**MHBL Response to:**

**Conformity Analysis of the Final Environmental  
Impact Statement (FEIS) for the Proposed Doris  
North Gold Project**

**prepared by:  
Indian and Northern Affairs Canada**

**March 15, 2004**

HOPE BAY JOINT VENTURE		
HOPE BAY PROJECT		
CORE ABA SAMPLES - DORIS MINERALIZED ZONE MEASURED NP vs CO <sub>2</sub> NP		
	PROJECT / ASSIGNMENT NO. VA101-7/1	NO. 1
	FIGURE 3.5

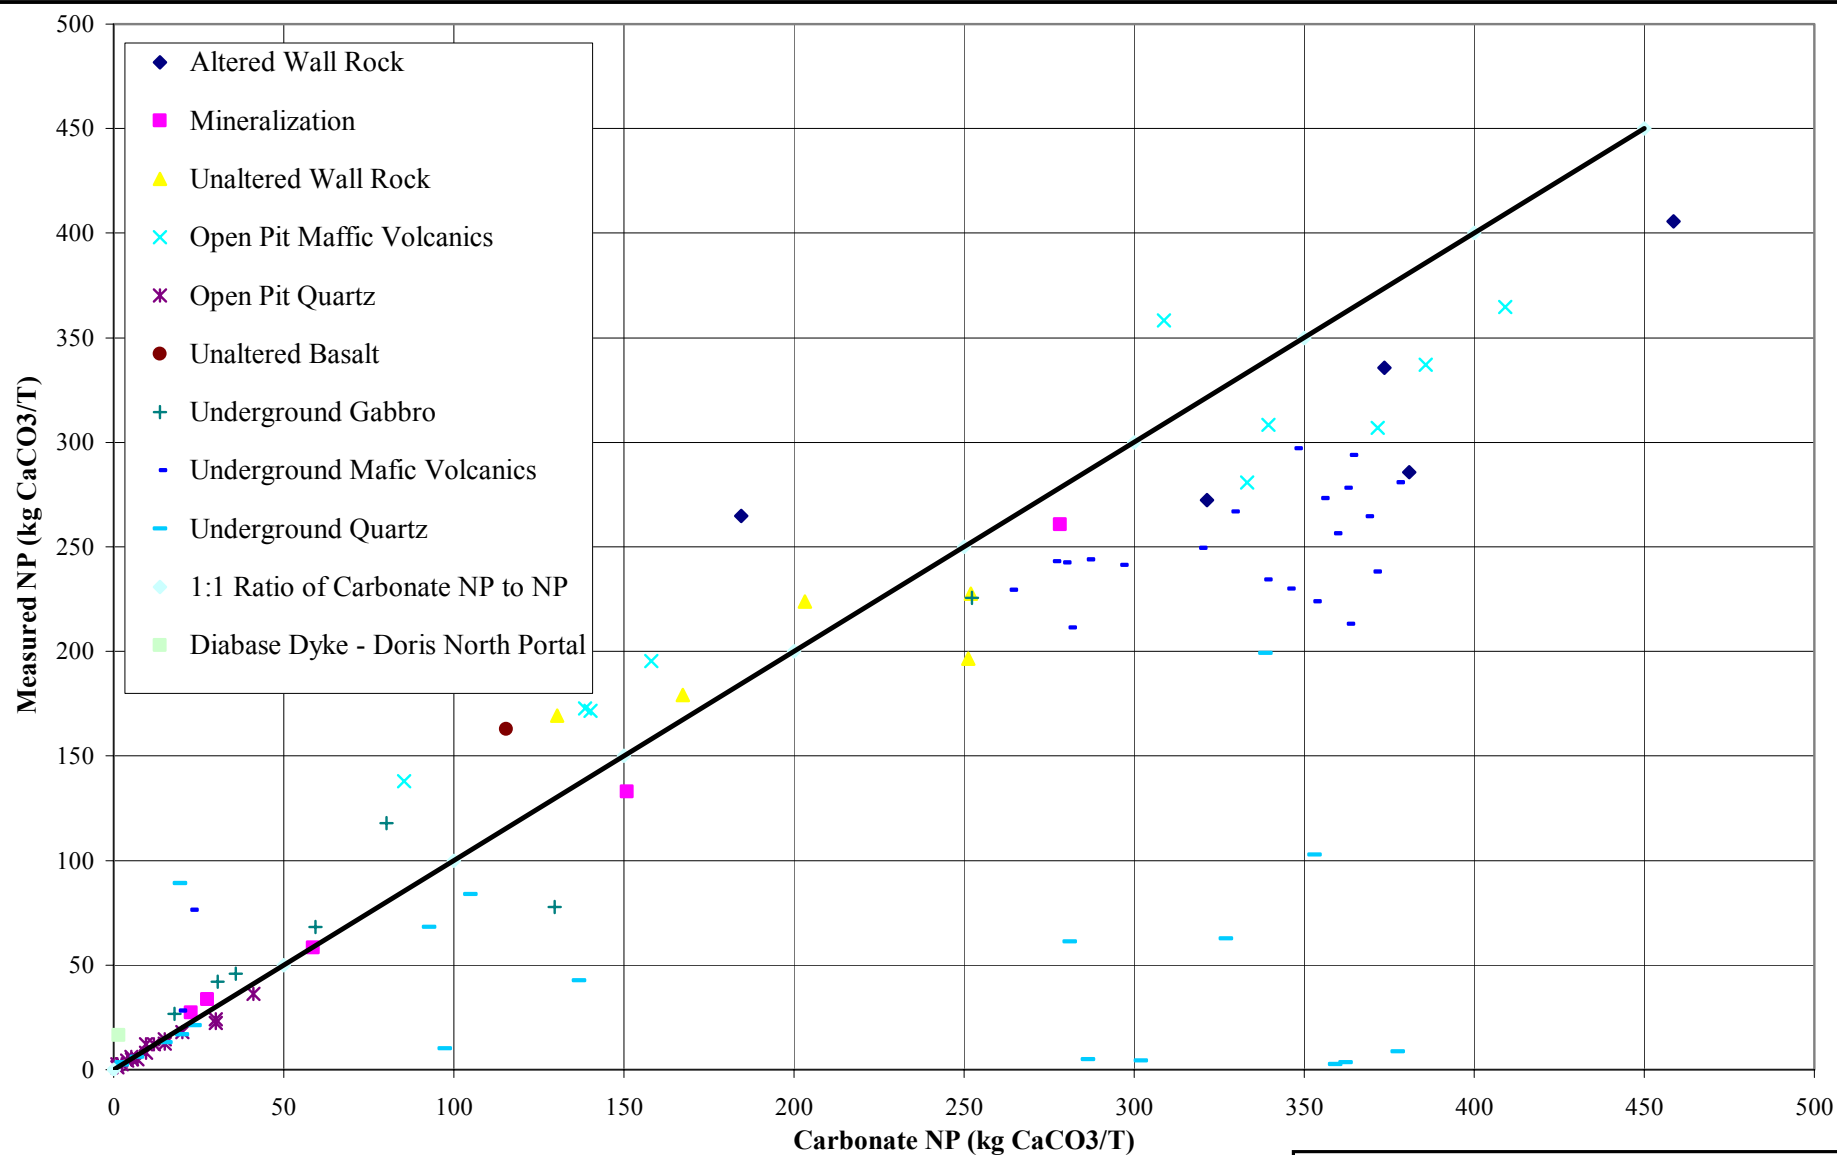
A total of 92 samples out of the 166 sample Doris North ABA data base were analyzed for both carbonate carbon neutralization potential and for the Sobek bulk neutralization potential. These results are compared in the attached Table A below. Of these 92 samples, two thirds had a carbonate-NP value that exceeded the measured Sobek-NP value. Figure 3.5 from Supporting Document B4 (copy attached) presents a plot of carbonate NP versus measured Sobek NP for these 92 samples. The 1:1 line shown on the graph indicates where carbonate NP is equal to the measured Sobek NP (i.e. where all of the measured NP is coming from carbonate mineral dissolution). A sample that plots above this line indicates that the measured NP is greater than the carbonate NP suggesting that NP is being contributed by both carbonates and other neutralizing minerals, such as fast weathering silicates. A sample that plots below the line indicates that the carbonate NP is higher than the measured Sobek NP indicating that there are carbonates in the sample that are not contributing net neutralization, such as Fe and Mn carbonates. Typical examples of these types of carbonates are siderite and ankerite (it should be noted that the text provided in Section 3.3.1.3 of Supporting Document B4 to the FEIS provided an incorrect analysis of the data presented in Figure 3.5) following

The following observations can be drawn from the data as presented in Figure 3.5:

- For UG quartz vein material, the carbonate NP is consistently higher than the corresponding Sobek NP values suggesting that for this material use of carbonate NP overestimates the measured NP quite significantly. This corresponds with the fact that iron carbonate mineralization is associated with the alteration associated with the mineralized quartz veins. For UG quartz vein material use of the Sobek NP will provide a more accurate measure of actual available NP than will carbonate NP. The data indicates that the iron carbonates present in this material are not contributing actual NP.

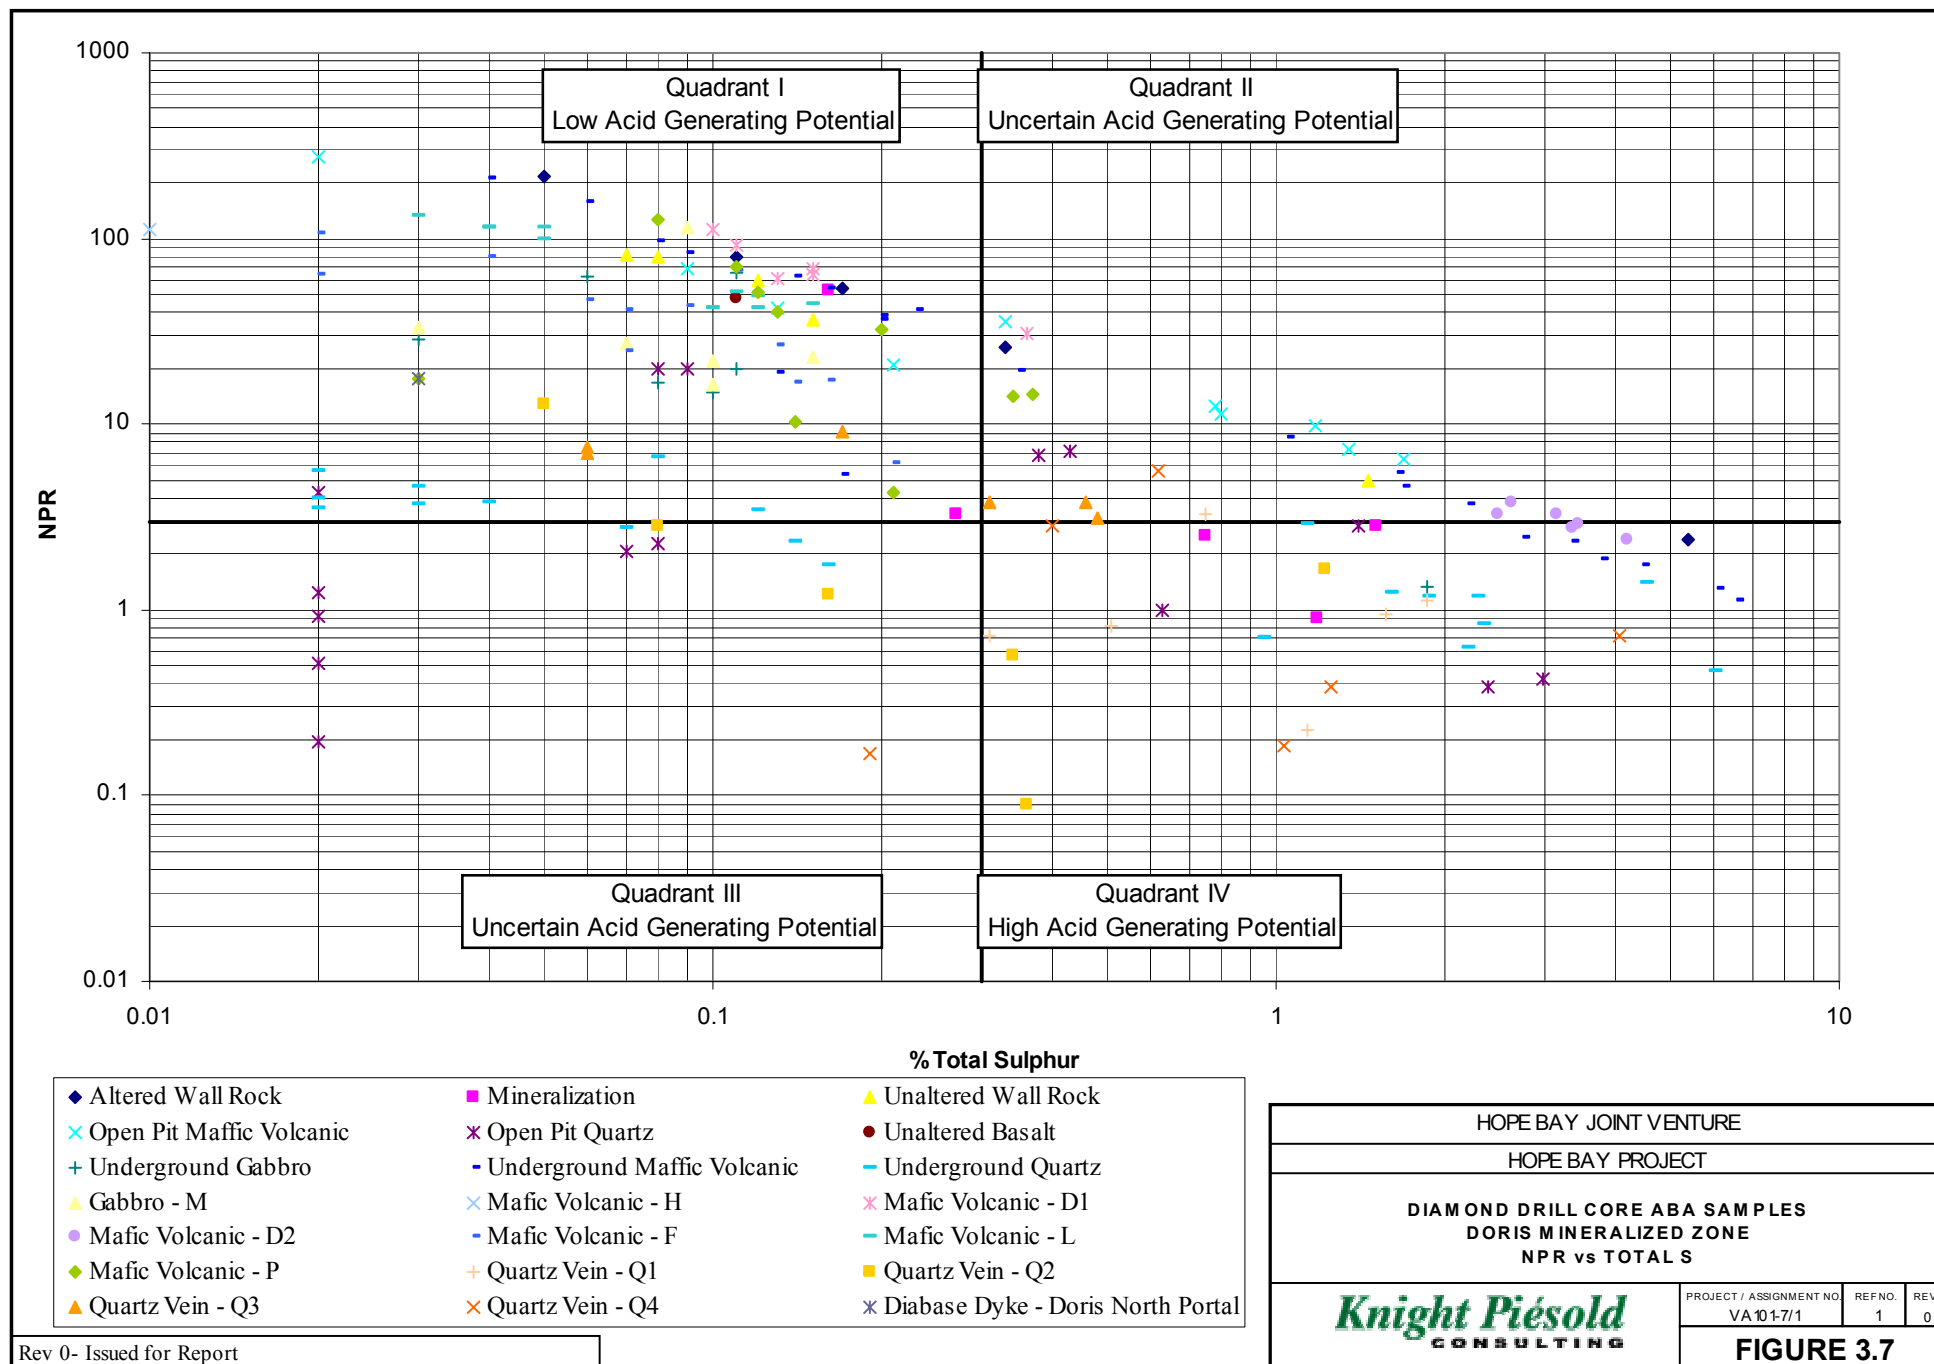
SD A1, Section 2.2.3 outlines a waste rock management plan, which includes a strategy for on-site classification of waste rock and handling methods. However, particular attention to the mafic volcanic group has not been addressed in the management plan. The plan discusses PAG rock vs. non-PAG rock, no particular rock types/subgroups have been singled out.

The proposed ARD management program calls on the geologist to first make an assessment of rock type and then to assess the presence of visible sulphide mineralization. Based on rock type the geologist will be able to predict the likelihood of the material being either within the mineralized zone or within the mafic volcanic halo from the visual identification of lithology. However the proposed ARD management program requires that despite this initial identification, if sulphide mineralization is present at a relative amount in excess of 0.30 wt% then the material should be considered potentially acid generating and segregated and managed accordingly until it can be demonstrated that the material is not potentially acid generating through use of conventional acid base accounting analyses. The criteria of 0.30 wt% was arbitrarily selected as being representative of a conservative criterion that is typically used in assessing ABA data.

Figure 3.7 in Supporting Document B4 (copy below) shows a plot of Neutralization Potential Ratio (NP) against wt% Total S for all 166 samples in the Doris North ABA database. The plot indicates that a total of 62 samples from that database had an NPR less than 3 (i.e. could be classified as being potentially acid generating). Of these 62 values only 12 had a Total S content of less than 0.30 wt% and all of these represented quartz vein rock type material. The other 50 samples all had Total S contents in excess of 0.30 wt%, the majority having well above 1 wt% Total S content. The plot also indicates that out of the 166 samples in the database, a total of 99 had a Total Sulphur content of less than 0.30 wt%, however a total of 87 of these samples had an NPR greater than 3 indicating that they are non-acid generating.

An alternative way of looking at this same data is shown in Figure A (attached) which plots NPR versus Total wt% S where the NPR values are plotted on a logarithmic scale versus the wt% S that is on a non-logarithmic scale. The plot demonstrates the small number of samples within the data base that have NPR values under 3 (potentially acid generating) and have a wt% Total S concentration under 0.30 wt%. All of these samples were of quartz vein material where the neutralization potential is relatively low due to the absence of carbonate mineralization.

In other words the ABA data base for the Doris North deposit suggests that for all rock types, other than the mineralized quartz veining, if the wt% Total S is below 0.30 wt% then the material is unlikely to be classified as being potentially acid generating. The quartz vein material typically only occurs within the mineralized ore zones and is thus unlikely to be extracted as waste rock.
